Markar Countersink Process Change

Markar Architectural Products, Inc. a subsidiary of Adams Rite Manufacturing Co.
260 Santa Fe Street, Pomona, CA 91767 Phone: 800-872-3267 909-632-2300 Fax: 800-232-6752

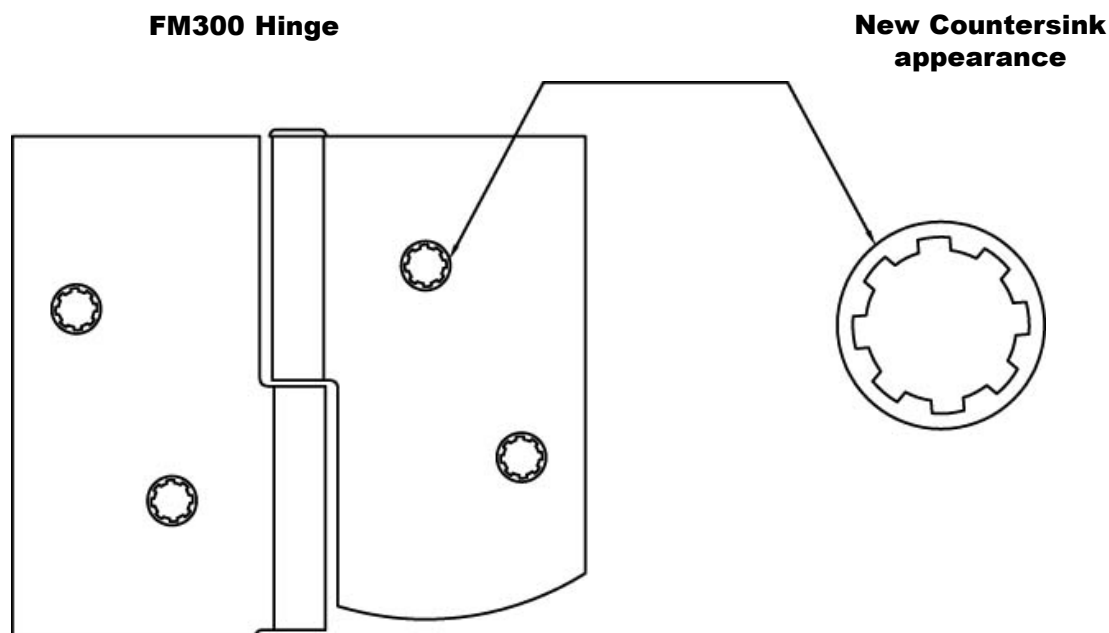
As a part of our continuing manufacturing process improvements, Markar is changing the method used in the way we countersink the mounting holes on Markar 300 series hinges. The new punch and coining process will insure accurate, repeatable quality through each hinge by providing a consistent depth and diameter to all mounting holes.

With this change, the appearance of the templated holes will change slightly. The hinges manufactured using the new process will feature holes with "internal teeth" appearance. There will be no other physical changes to the hinge as a result of this process change, and this will in no way affect the performance or durability of the product.
